CLARK COUNTY, NEVADA BID NO. 603676-15 INTERSECTION IMPROVEMENTS AT TENAYA WAY AND WARM SPRINGS ROAD

ADDENDUM NO. 1

CONTRACT DRAWINGS L-2050

PIPE CONNECTION TO THE EXISTING RCB

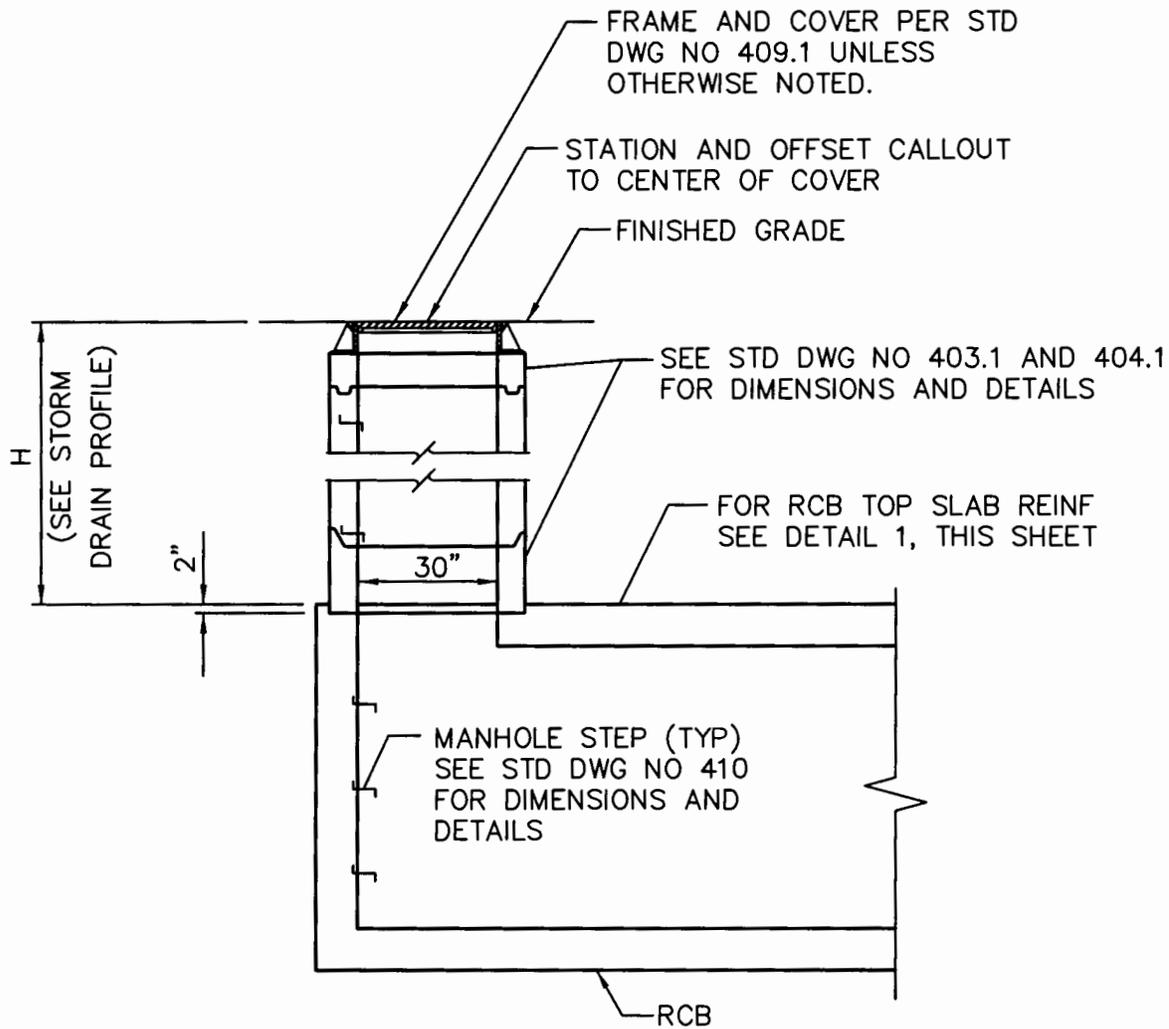
- a) **Added** Detail 2 Pipe Connection to the Existing RCB (see attached).
- b) Detail A, Note pointing to the reinforcing steel dowels: **Added** "12 inch embedment in existing RCB".
- c) Detail A, Note pointing to the reinforcing steel dowels: **Revised** leader to point to dowel in existing RCB.
